To: Development Permit Panel
From: Wayne Craig
Director of Development

Date: August 19, 2014
File: DP 13-646028

Re: Application by Sandhill Homes Ltd. for a Development Permit at 9080 No. 3 Road

2. **DP 13-646028 – 12-UNIT TOWNHOUSE DEVELOPMENT**

PLAN #1

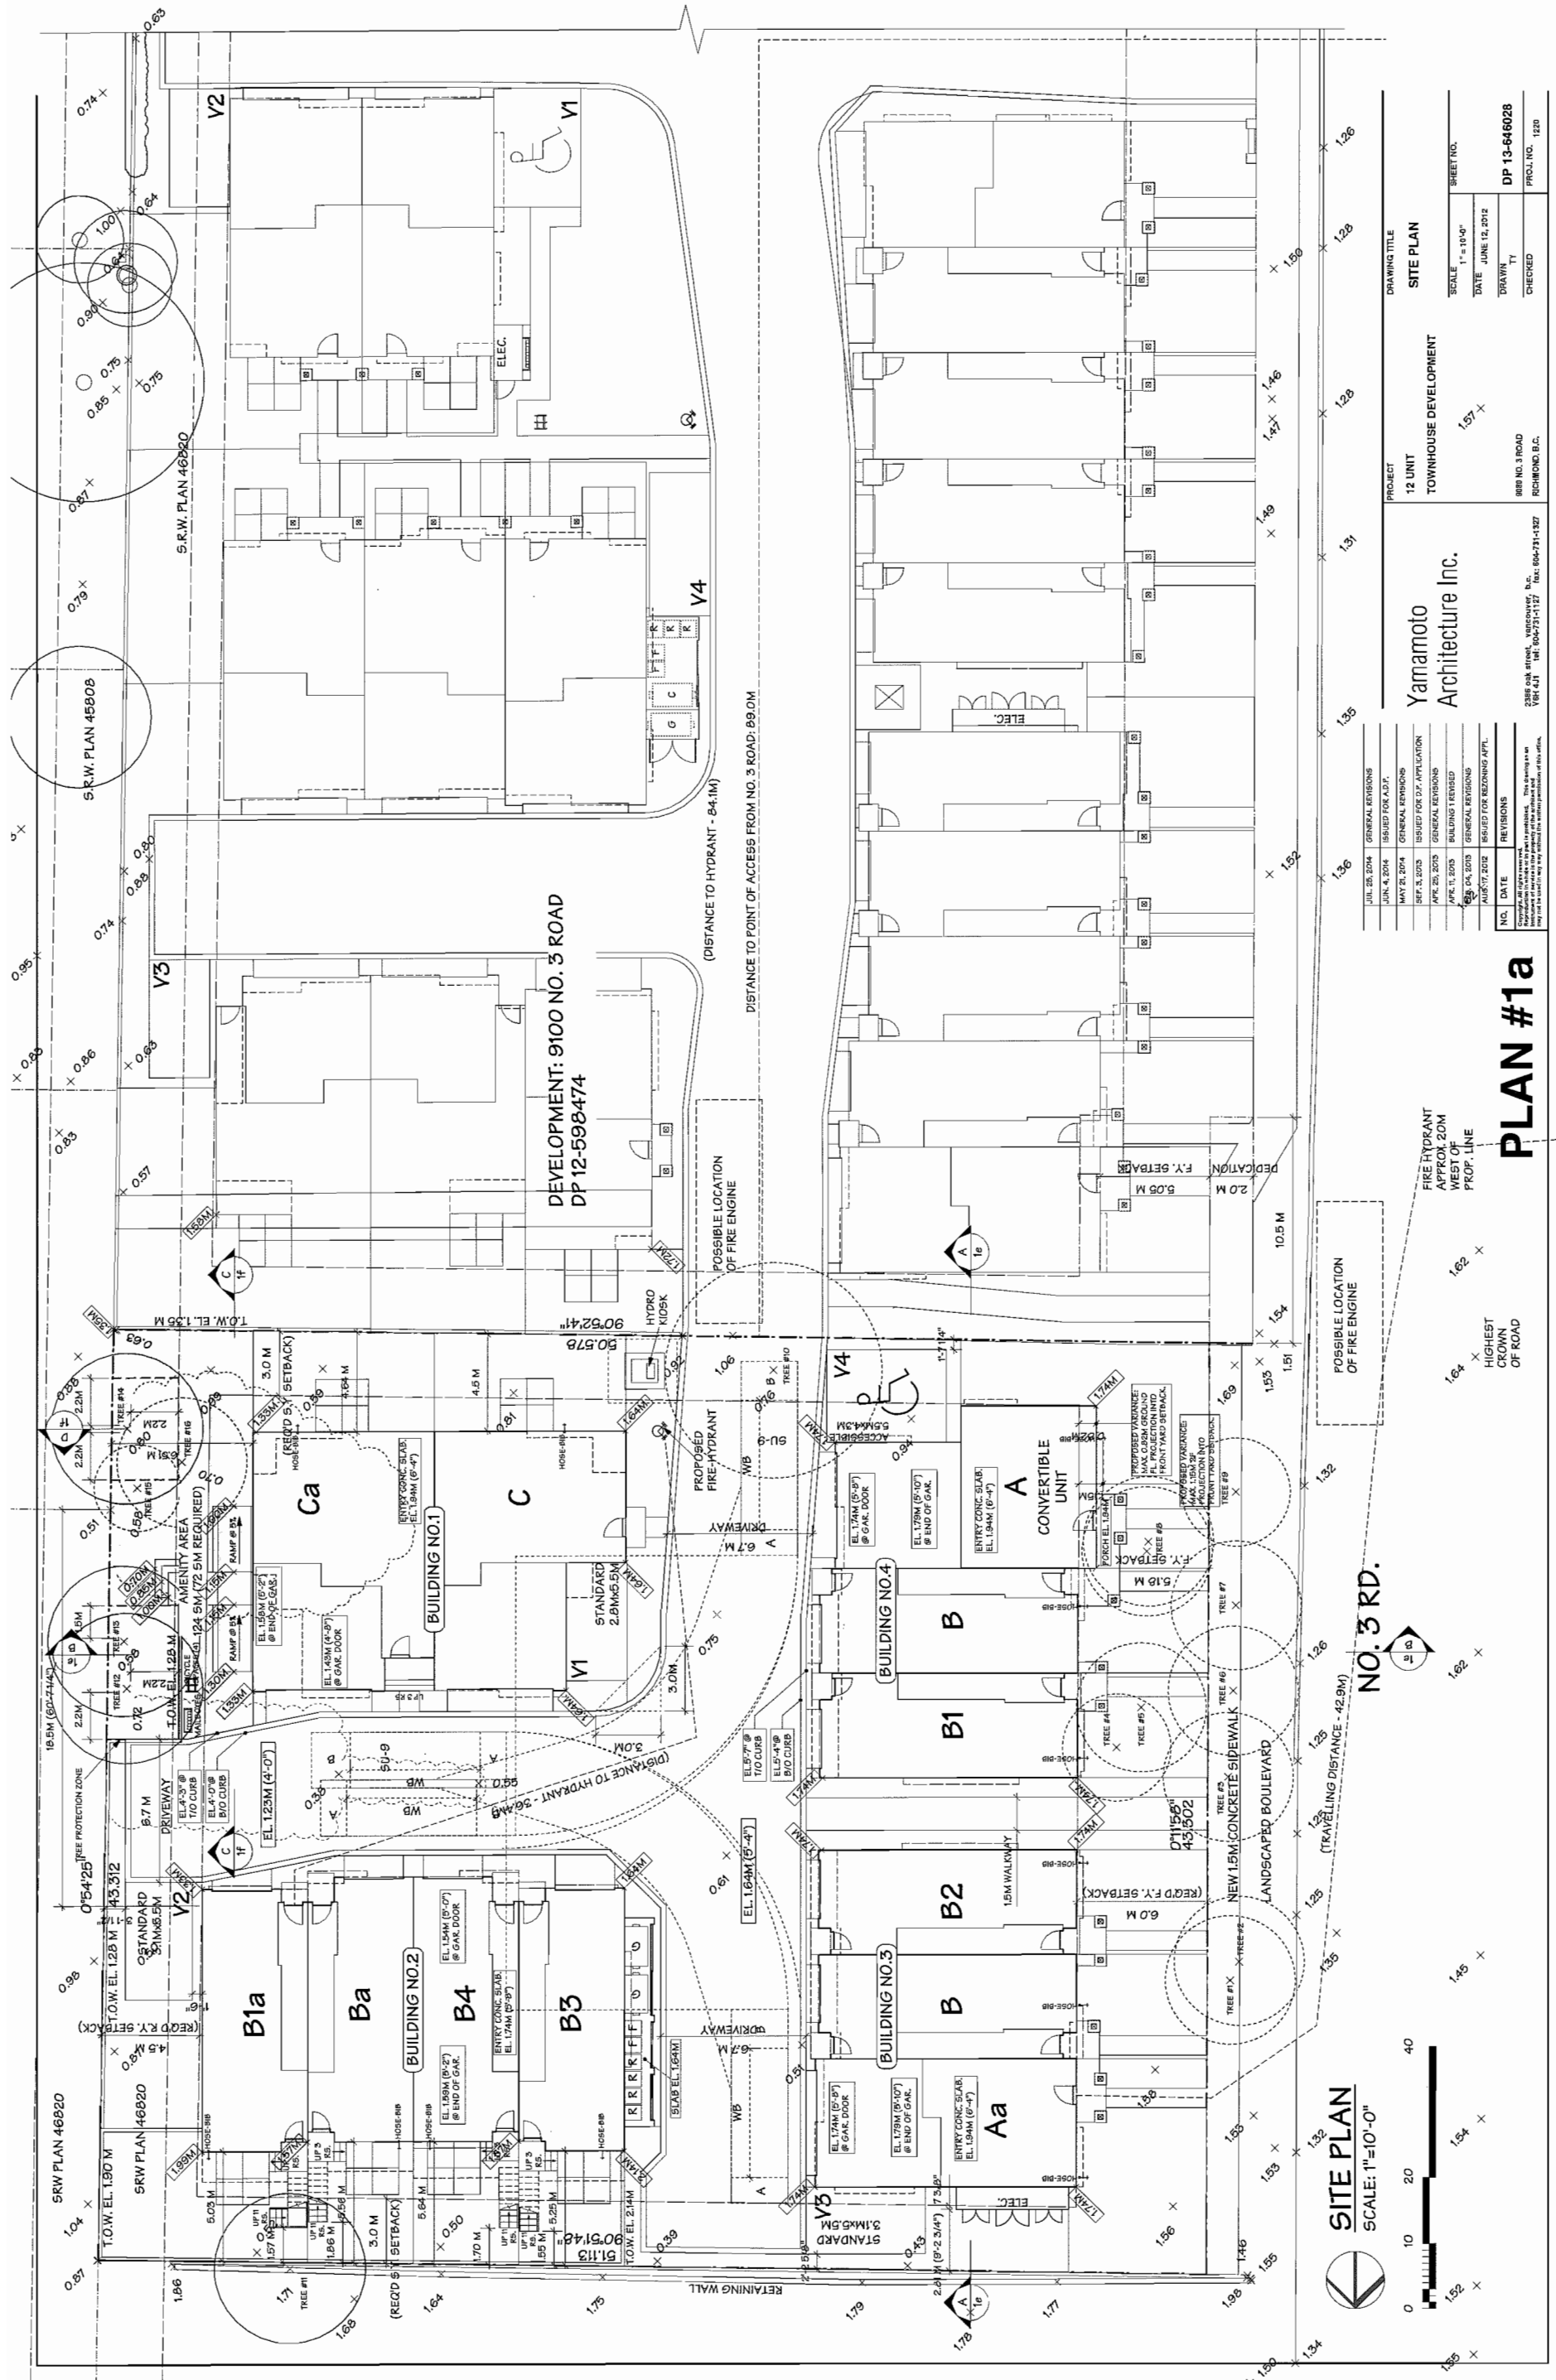
- concern on the location of the outdoor amenity space at the southeast corner for the following reasons: (i) it is out of view from the townhouse units in the subject development, (ii) it has very little overlook from the adjacent townhouse units, and (iii) it poses a safety concern;

- agree with the previous comments regarding the location and narrowness of the outdoor amenity space at the southeast corner of the site; consider (i) moving Building No. 1 further to the west to enlarge the outdoor amenity space or (ii) making some modifications to open up the amenity space;
 - *Configuration of Outdoor Amenity area complies with the Development Permit Guidelines in the OCP.*
 - *The landscaping has been carefully planned out in relation to the grade changes and tree retention to provide a natural play area with elements from nature such as boulders, logs, etc. The amenity area has been planned so that there will be clear view across the play area and from the mail pick up area.*

- agree with previous comments regarding the location of the outdoor amenity space as it should be visible from the second floor of the adjacent townhouse units;
 - *Additional window added to the second floor on the east elevation of Building 1.*

- the outdoor amenity space could be relocated to a more central location to enhance the safety of children;
 - *Moving it to a more central location could cause possible vehicular concerns as it will be by the entry drive aisle.*
 - *There will be less sunlight exposure if the amenity space was relocated between Buildings 3 and 4.*

- children may like the proposed location for the outdoor amenity space due to the presence of trees; a more central location might give rise to vehicular traffic safety concerns;

- ***We concur.***
- the applicant should improve the visibility of the outdoor amenity space from the adjacent townhouse units in the subject development;

- *Additional windows added to the east elevation of Building 1 (2 on ground floor, 1 on second floor).*
 - *There is a clear view into the play area from the terminus of the internal drive aisle.*

- *The adjacent mail pick up area overlooks the outdoor amenity area.*
 - *The adjacent yard of Unit Ca, Building 1 has a low 42" fence which also provides passive surveillance.*

- *Building 2, Unit B1a overlooks the outdoor amenity area from the 2nd and 3rd floor.*

- ***There is more sunlight exposure at the southeast corner of the site into the proposed amenity space.***
- like the variety of materials proposed for the project; nice variations in building elevations;

- ***Additional windows added to the east elevation of Building 1 (2 on ground floor, 1 on second floor).***
- it is difficult to respond to the proposed design of the project due to the lack of information regarding the future development to the north of the subject site;
